Rezoning Transportation Analysis

Petition Number: Insert Zoning Petition #2021-200

Date	Description
12-28-21	First Review (TNM)

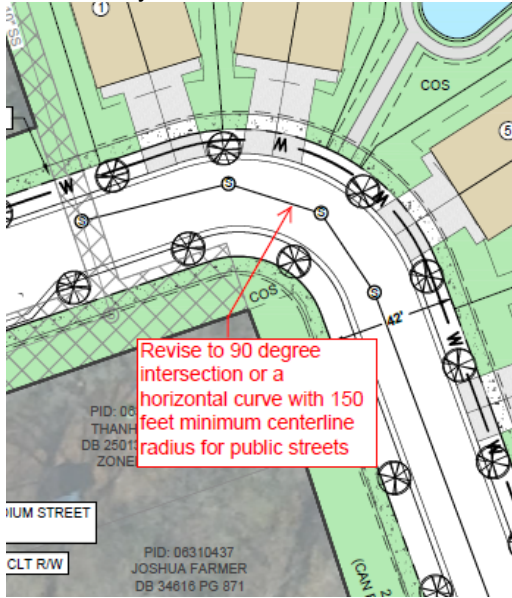
3. Revise site plan and conditional note(s) to commit to dedicating 28-feet of right-of-way from the site's proposed road centerline (56-feet total). The site plan shall label and dimension the right-of-way from the proposed road centerline.
4. Revise site plan and conditional note(s) to commit to construct an 8-foot planting strip, and 6-foot sidewalk on Wildwood Avenue and the site's internal roads per Chapter 19. The site plan shall label and dimension both items from the back of curb and the road centerline.

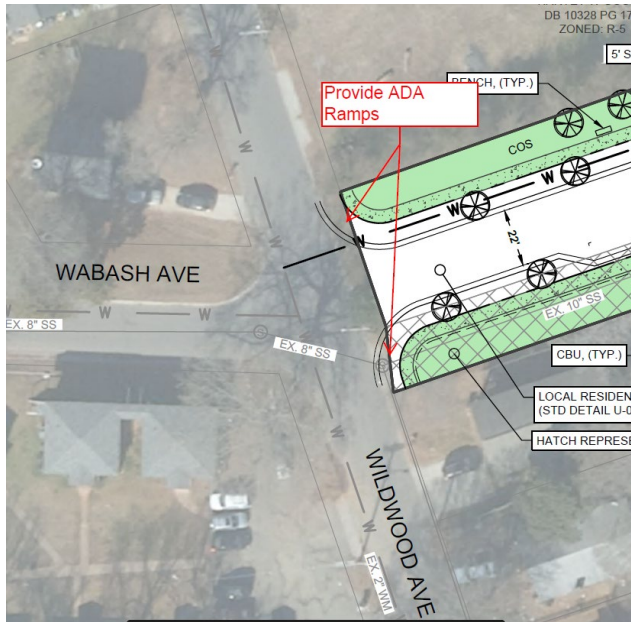
5. Revise site plan to propose at 90-degree intersection in the location of the horizontal curve. Alternatively, a horizontal curve can be installed with a minimum centerline radius of 150-feet.
